Corridor 11-228

Bend to Boise Corridor

Corridor Purpose and Rationale

Figure 3. Map of Conflict Areas in Vicinity of Corridor 11-228

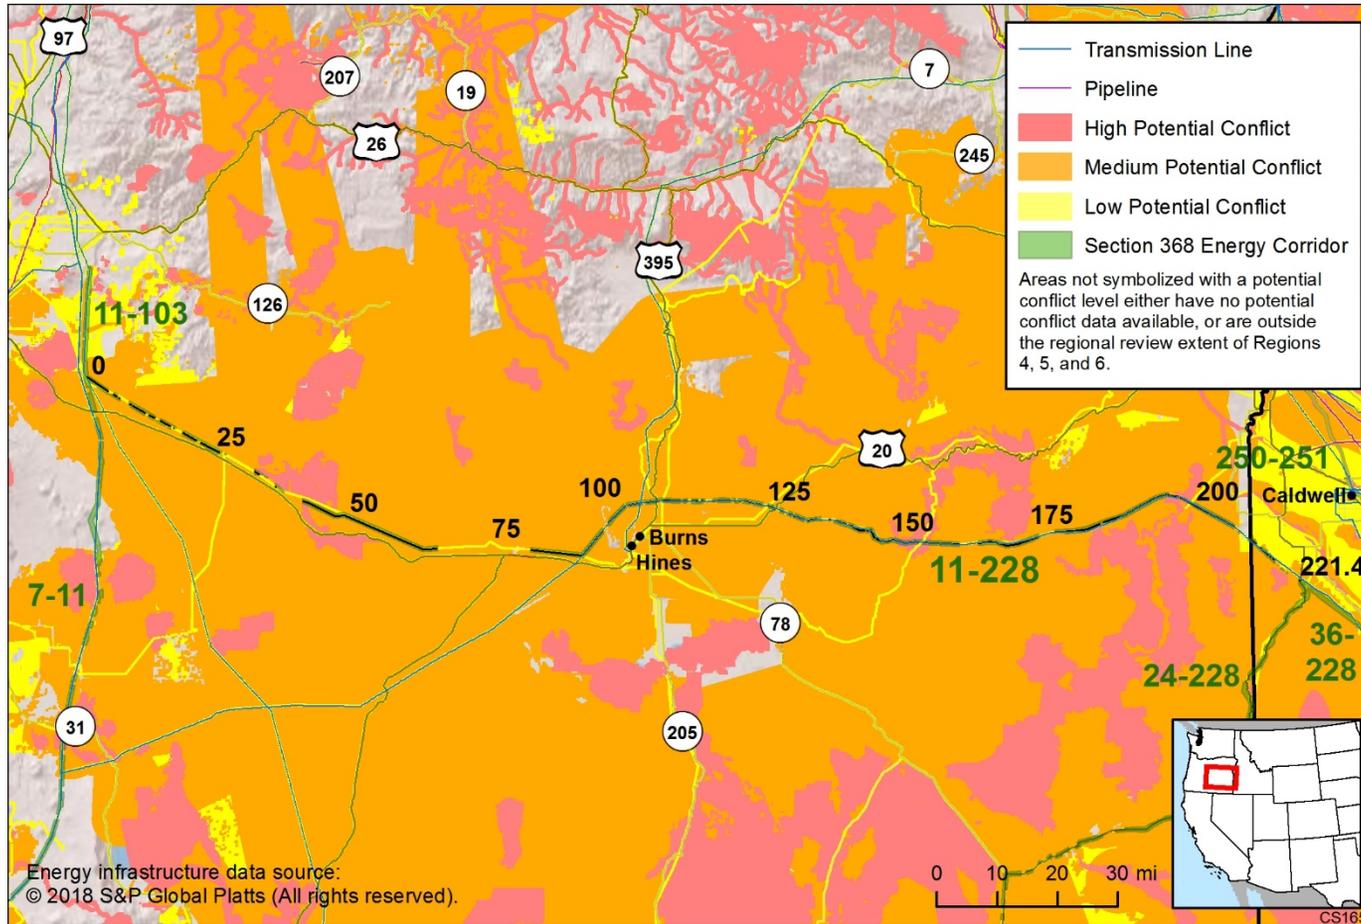
Figure 3 reflects a comprehensive resource conflict assessment developed to enable the Agencies and stakeholders to visualize a corridor’s proximity to environmentally sensitive areas and to evaluate options for routes with lower potential conflict. The potential conflict assessment (low, medium, high) shown in the figure is based on [criteria](#) found on the WVEC Information Center at www.corridoreis.anl.gov. To meet the intent of the Energy Policy Act and the Settlement Agreement siting principles, corridors may be located in areas where there is potentially high resource conflict; however, where feasible, opportunity for corridor revisions should be identified in areas with potentially lower conflict.
